Interactive comment on “BioRT-Flux-PIHM v1.0: a watershed biogeochemical reactive transport model” by Wei Zhi et al.

Anonymous Referee #1

Received and published: 17 August 2020

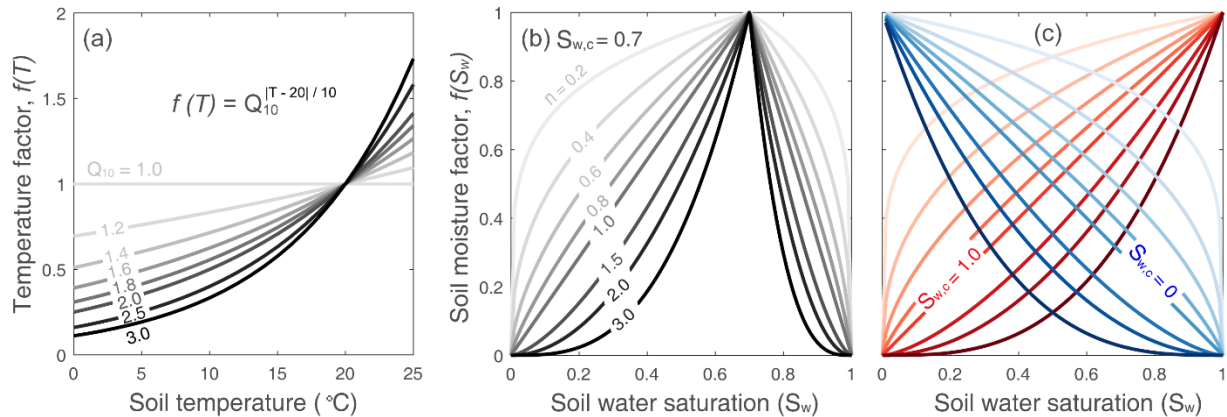
- fig 4: you mention a lot of things which were not discussed in the model section. for example, thermal effects (evapotranspiration, solar radiation, air temperature) --> how do they impact what has been discussed. Basically, most of the complexity from figure 1 and figure 4 was absolutely not addressed in the model section. are there some missing references?

Response: Sorry for the confusion. This paper is to introduce BioRT-Flux-PIHM focusing on recent new developments. So some of the complexity in Figure 1 or Figure 4 regarding land surface, hydrological, and reactive transport processes have been described and explored in previous papers (Bao et al., 2017; Shi et al., 2013). For example, ET is a core process in the land-surface and hydrological model (Flux-PIHM) and its interactions with soil temperature, sensible and latent heat fluxes (surface energy balance) have been explored in Shi et al. (2013). As mentioned earlier, we also revised the intro to better define the scope.

We also added more detailed description (Line 339 – 368) and Figure 4 of rate dependence on T and soil moisture in the manuscript.
